Safety Defect and Noncompliance Report Guide for Vehicles
PART 573 Defect and Noncompliance Reports

On: **August 12, 2008, Pleasure-Way Industries** [MFR] decided that (a defect which relates to motor vehicle safety)(a noncompliance with Federal Motor Vehicle Safety Standard No.**571.108**) exists in the motor vehicles listed below, and is furnishing notification to the National Highway Traffic Safety Administration in accordance with 49 CFR Part 573 Defect and Noncompliance Reports.

Furnish the manufacturer's identification code for this recall (if applicable): **08V-159**

RECALL NOTICE

MEASURES TAKEN TO CORRECT THE DEFECT

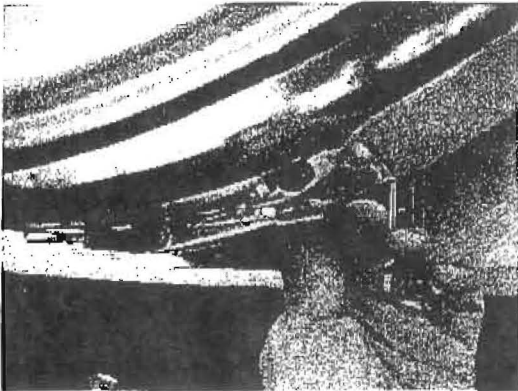
The hitch mount spare tire carrier and tire impede the visibility of the driver rear tail light at a 45 degree angle.

Remove the hitch mount spare tire carrier and all associated hardware.
